John Deere - HRN-GR09K1

INTRODUCTION

Harness modification requirement for some John Deere vehicles using GoRugged with HRN-GR09K1.

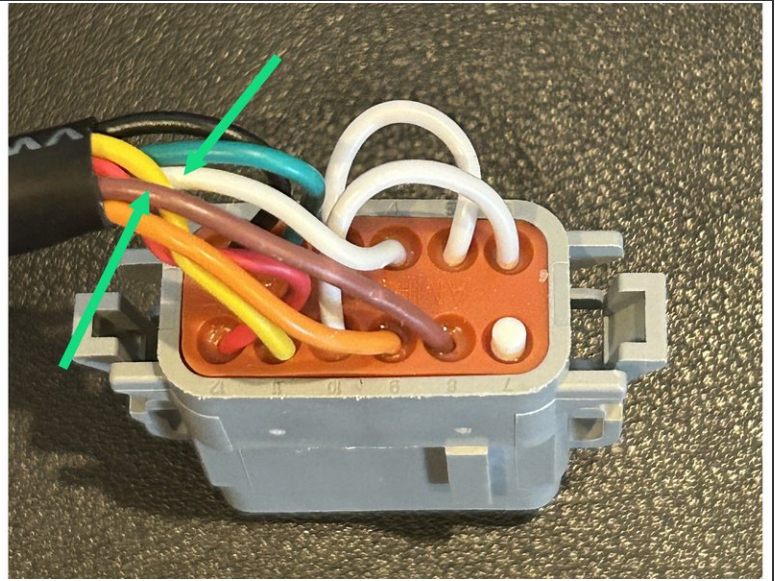
In some cases you will see error codes on the dash and lose joystick functionality.

The modification to remedy this is to cut the pins F and G on the harness.

- ❗ Cut the **Brown wire** and **White wire** as shown in the image.
- ☑ Snip the wire close to the harness to avoid a floating wire, and insulate with tape.
